# Access Compliance Report

## Public Rights-of-Way

Intersection ID: 8002	Main Street: N_HOSKINS_RD	Cross Street: WOODMAN_AV	Location: NE
ADA ID: 9D619FB4F840	Ramp Type: Perp	Initial Pass/Fail: Fail	Overall Compliance: No
Severity Score: 33.75			
Codes/Mitigation Info/Possible Solution		Field Measurements/Component Compliance

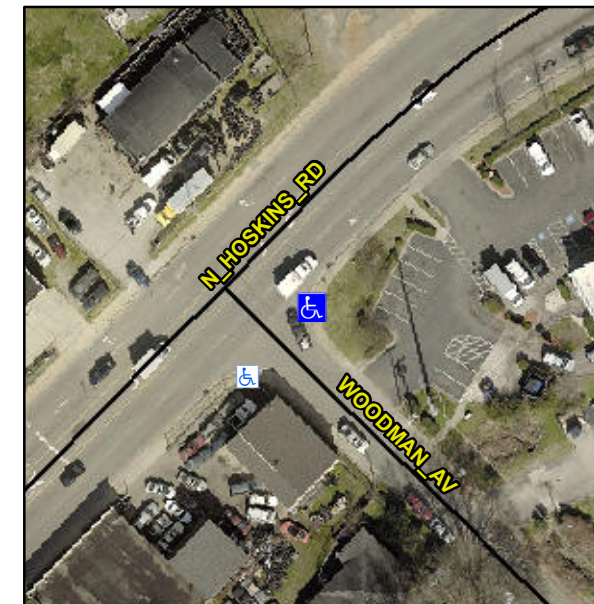
**Not Found, R304.5.1, R304.5.3**

Compliance	Description	Data	Compliance	Description	Data
N/A	Ramp Length (in)	57.0	Yes	Ramp Slope (%)	5.8
No	Ramp Width (in)	44.0	No	Ramp XSlope (%)	9.2
N/A	Flare Type LT	N/A	N/A	Flare Type RT	N/A
N/A	Flare Slope LT (%)	N/A	N/A	Flare Slope RT (%)	N/A
N/A	Flare Traversable LT?	N/A	N/A	Flare Traversable RT?	N/A
N/A	Landing Length (in)	N/A	N/A	DWS Provided?	N/A
N/A	Landing Width (in)	N/A	N/A	DWS Contrast?	N/A
N/A	Landing Slope (%)	N/A	N/A	DWS Length (in)	N/A
N/A	Landing X Slope (%)	N/A	N/A	DWS Full Width?	N/A
N/A	Landing Curb? (Y/N)	N/A	N/A	DWS Offset (in)	N/A
N/A	Shared Landing?	N/A			
N/A	Gutter Ponding?	N/A	N/A	Gutter Slope (%)	N/A
N/A	Gutter Lip Ht (in)	N/A	N/A	Gutter X Slope (%)	N/A
N/A	Painted X Walk1?	No	N/A	Painted X Walk2?	N/A
	X Walk 1 Direction	To SW		X Walk 2 Direction	N/A
N/A	X Walk 1 Width (in)	N/A	N/A	X Walk 2 Width (in)	N/A
	X Walk 1 Slope (%)	2.7		X Walk 2 Slope (%)	N/A
	X Walk 1 X Slope (%)	7.2		X Walk 2 X Slope (%)	N/A

**Remove & Replace Entire Ramp.**
